Re: Administrative Order 2RF-219
PLU Row 2 West Recycling Containment Variance Request
Facility ID (fVV2507951055)

XTO Permian Operating, LLC (OGRID: 373075) respectfully requests a variance to the approved C-147 application package for the PLU Row 2 West Recycling Facility Containment (frac pond) Permit 2RF-219 Recycling Facility ID (fVV2507951055).

FENCE DETAILS
OF
PROJECT NAME: POKER LAKE UNIT ROW 2
WEST FRAC POND

SHEET:
15 of 16
CS-503

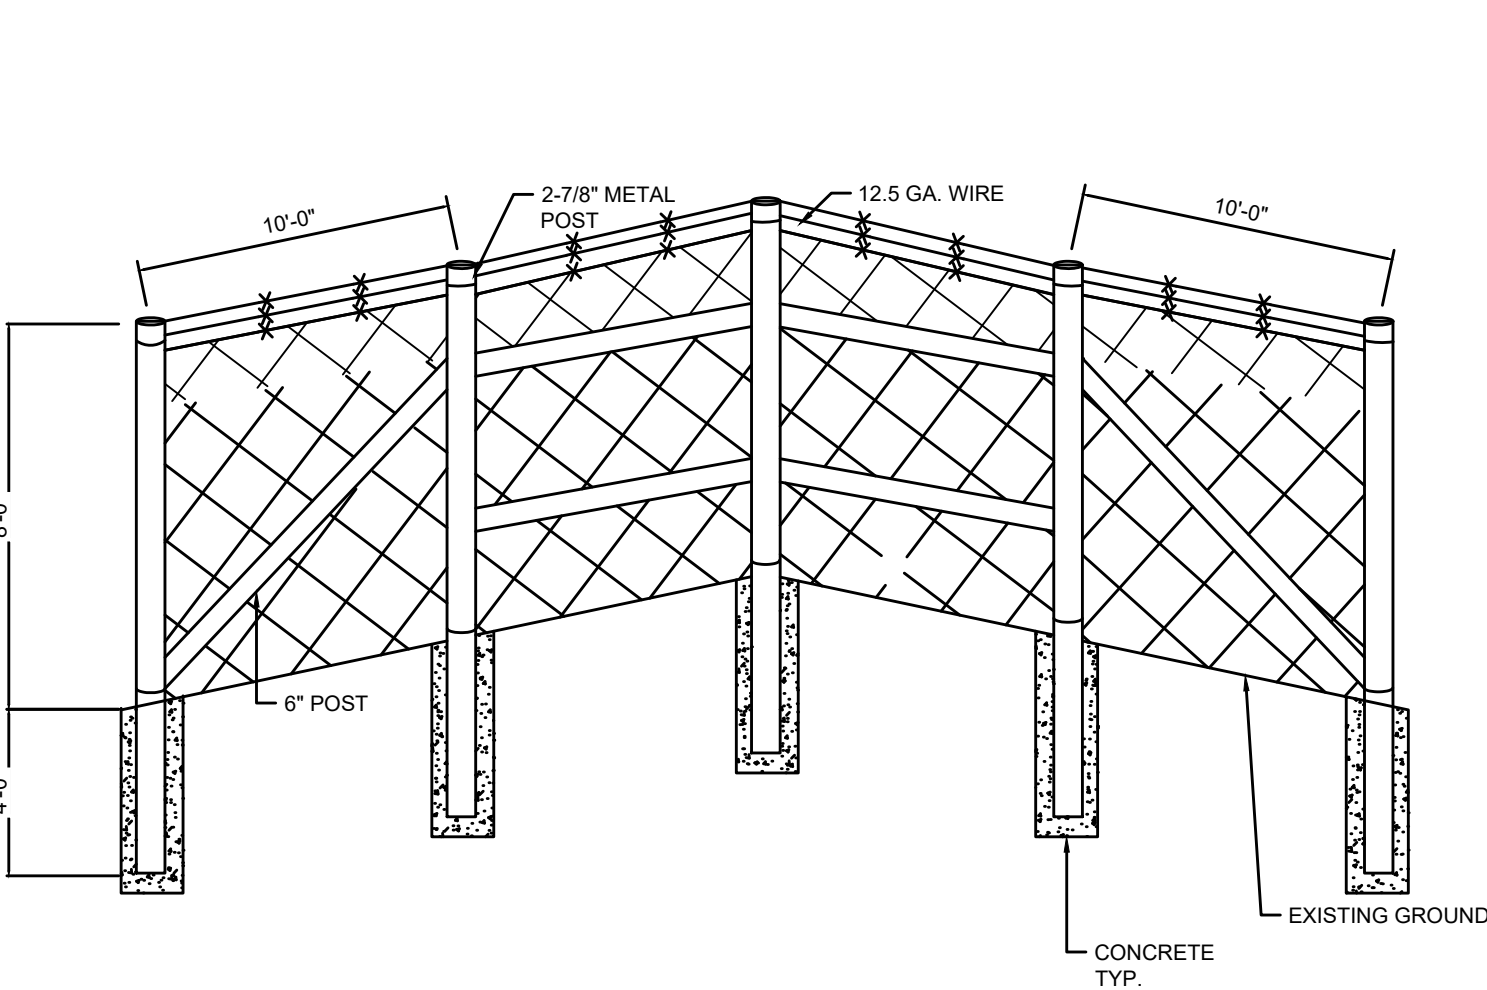
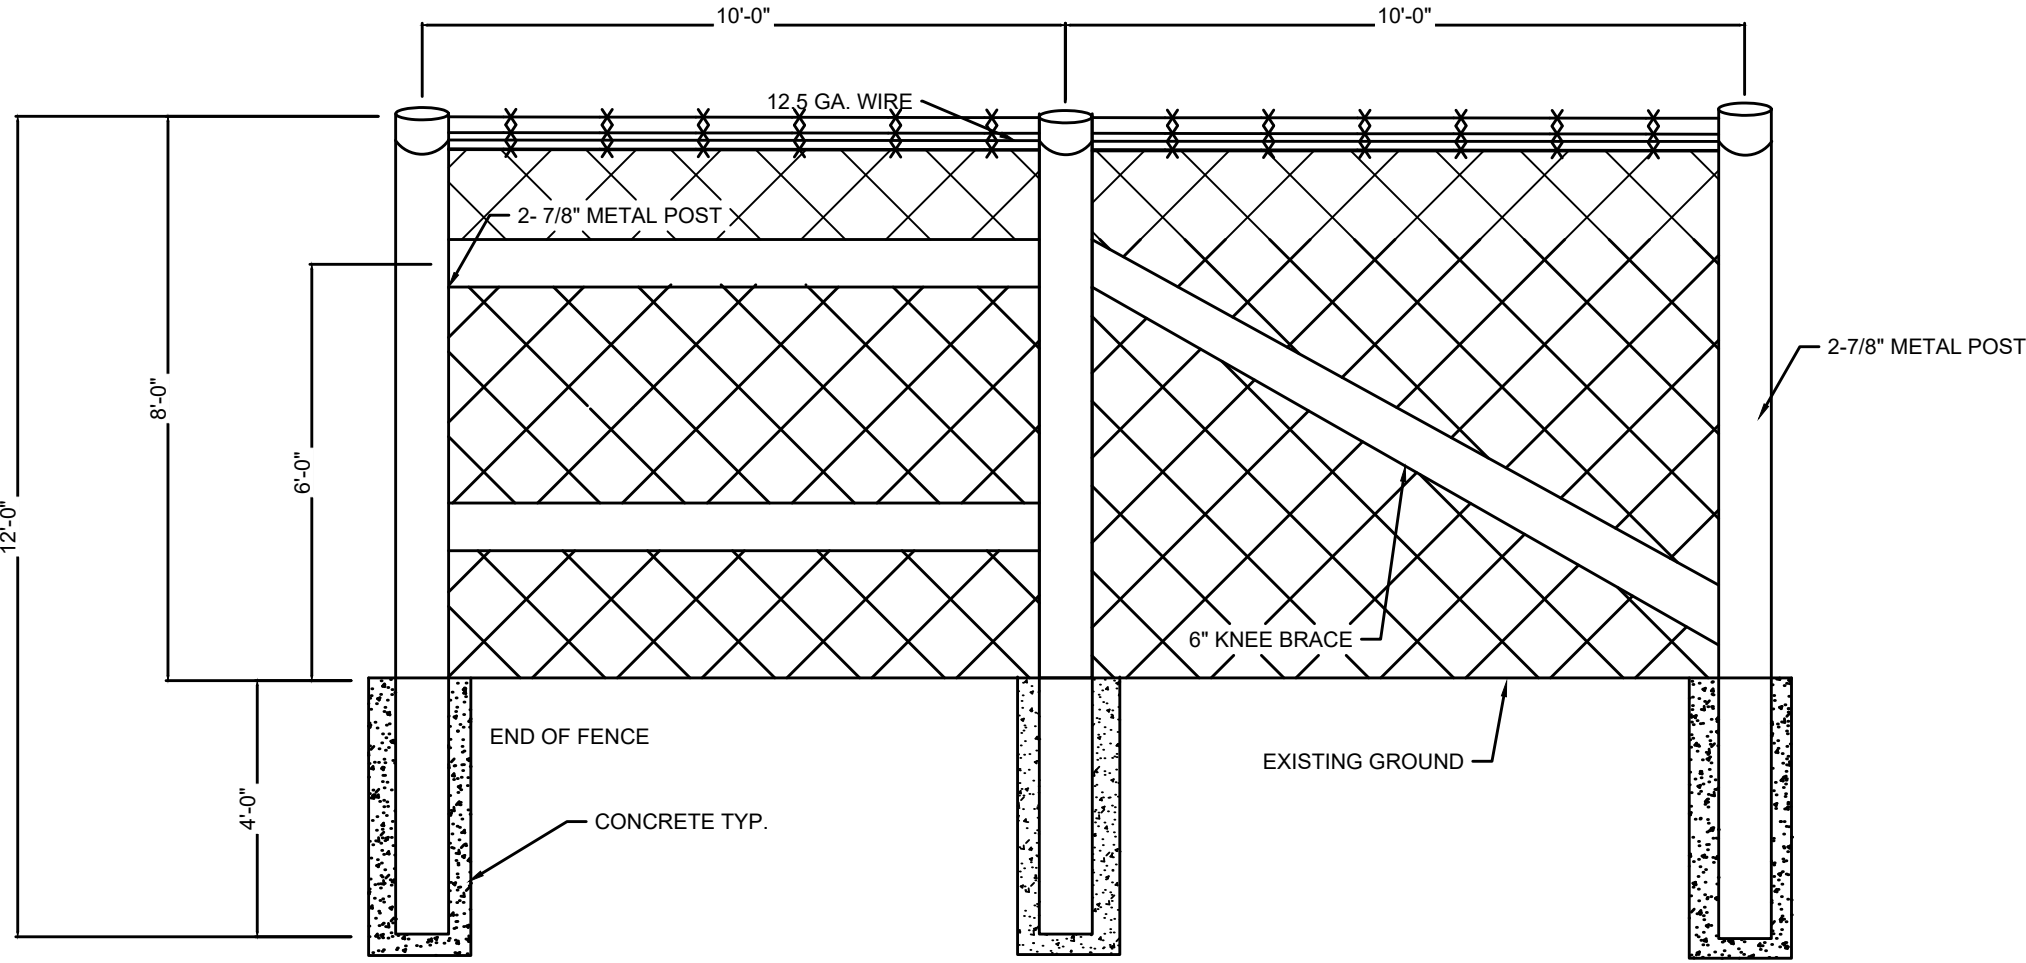
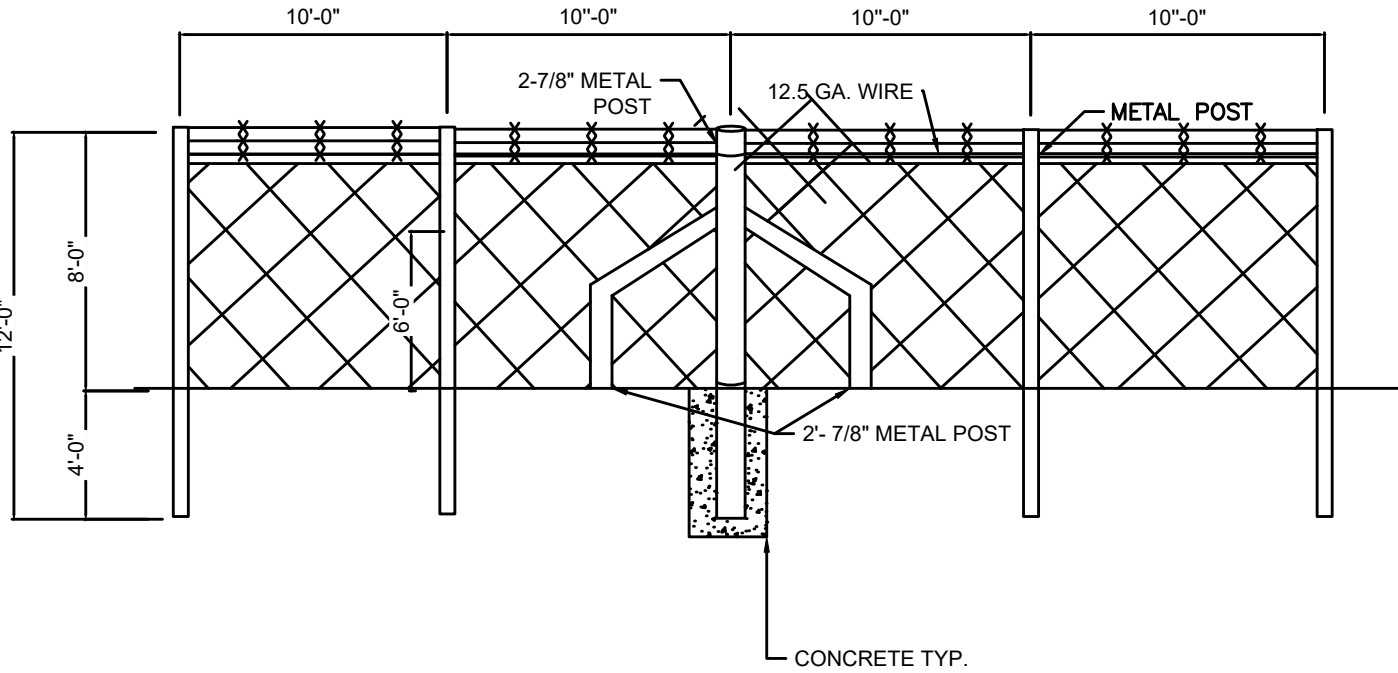
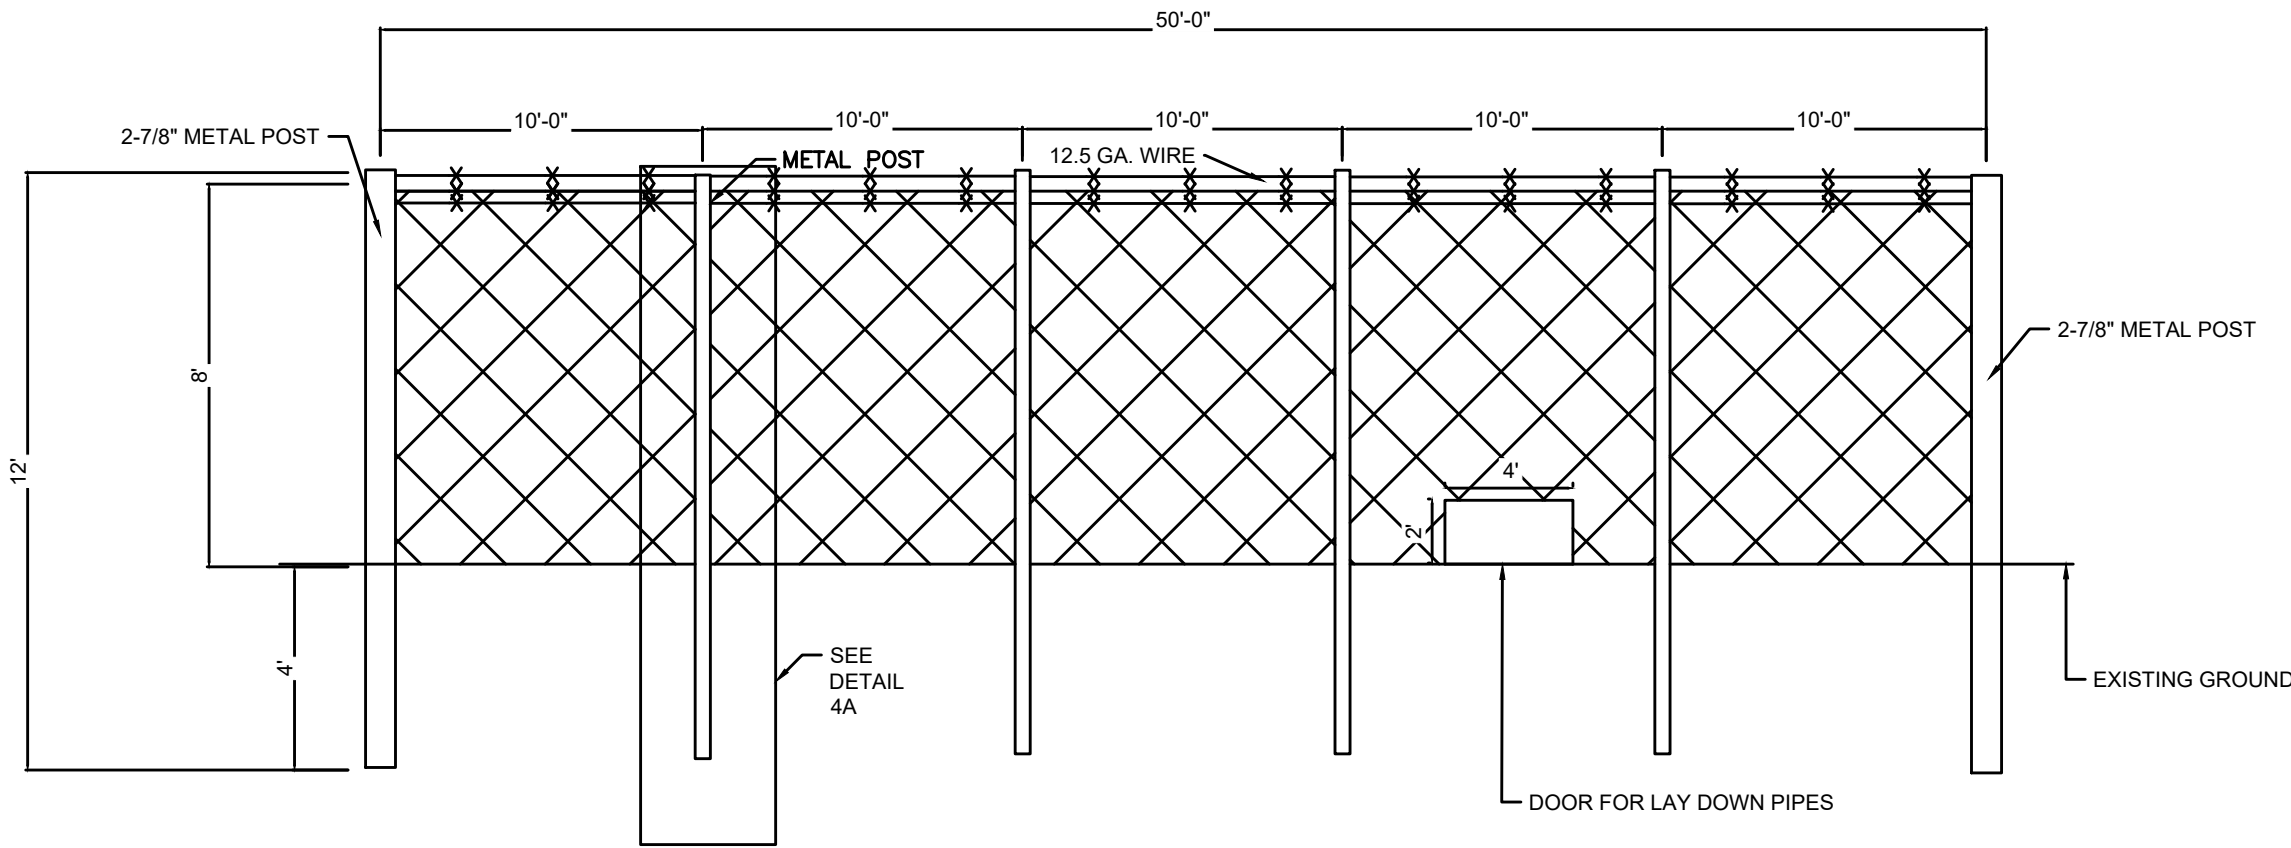
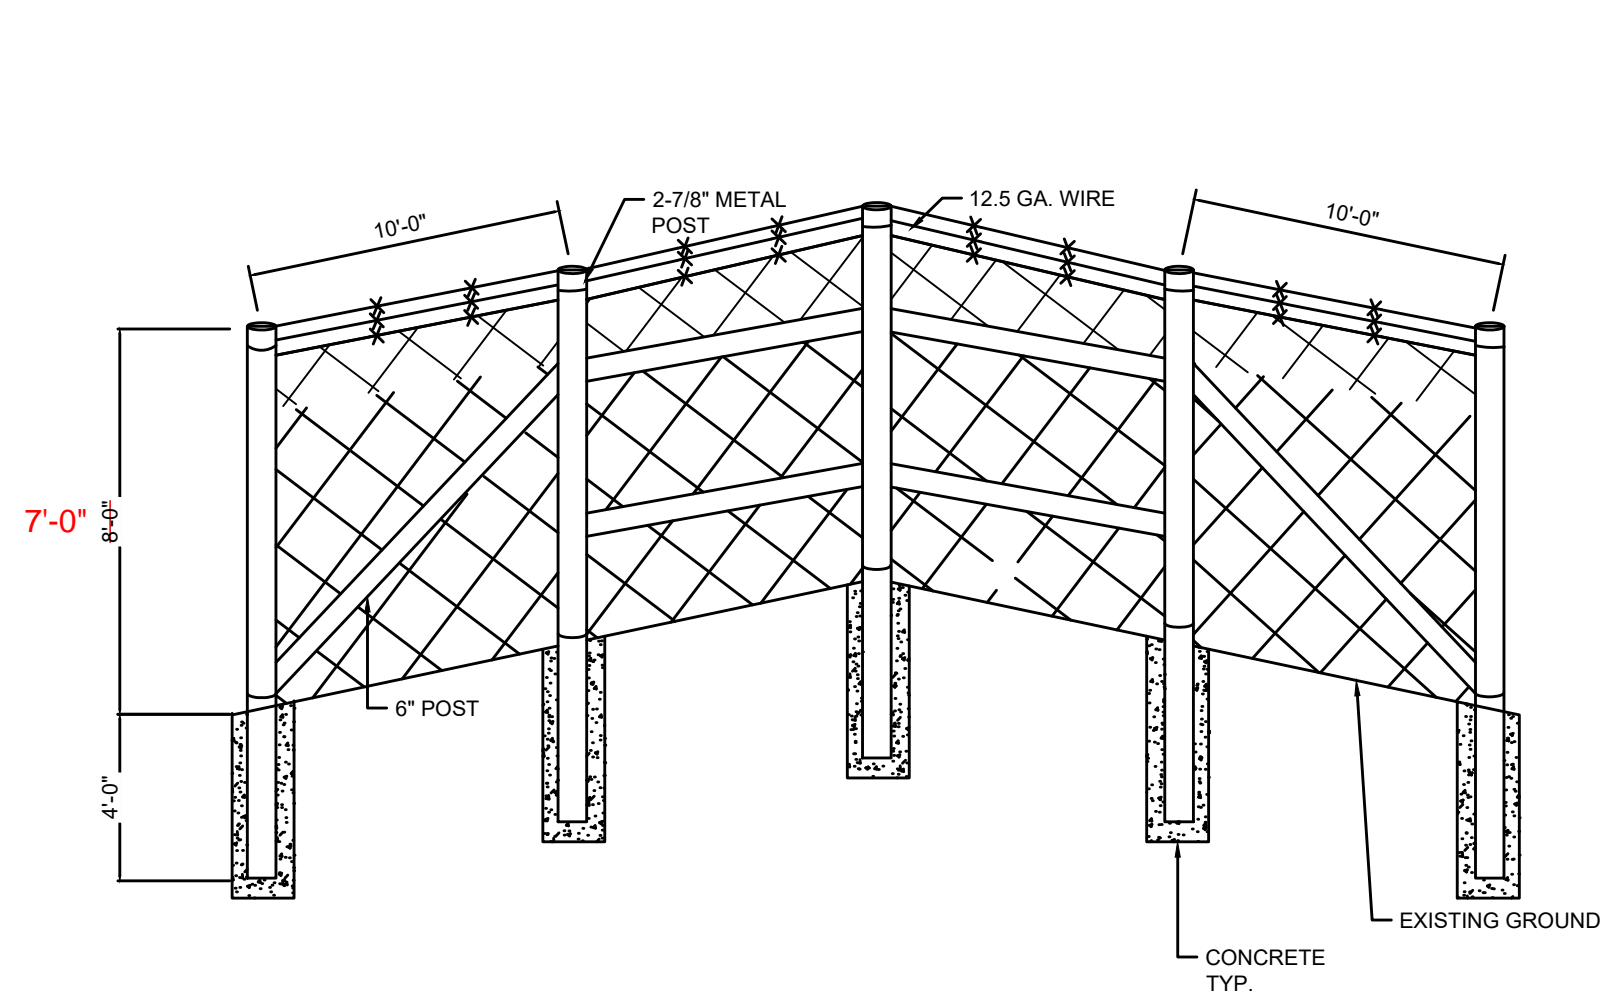
Due to a construction oversight, the originally specified fence height of 8 ft. was not achieved. The as-built fence height is 7 ft. XTO Permian Operating, LLC respectfully requests a variance to the as-approved C-147 application package to incorporate the as-built fence height of 7 ft.

The originally submitted engineered fence drawings can be seen in "CS-503.pdf" (attached). The redlined fence drawings can be seen in "CS-503-redlined.pdf" (attached).

- The modification request to the approved variance to install a wire mesh, game fence, seven (7) feet in height, instead of the originally permitted fence height of 8 ft is approved.
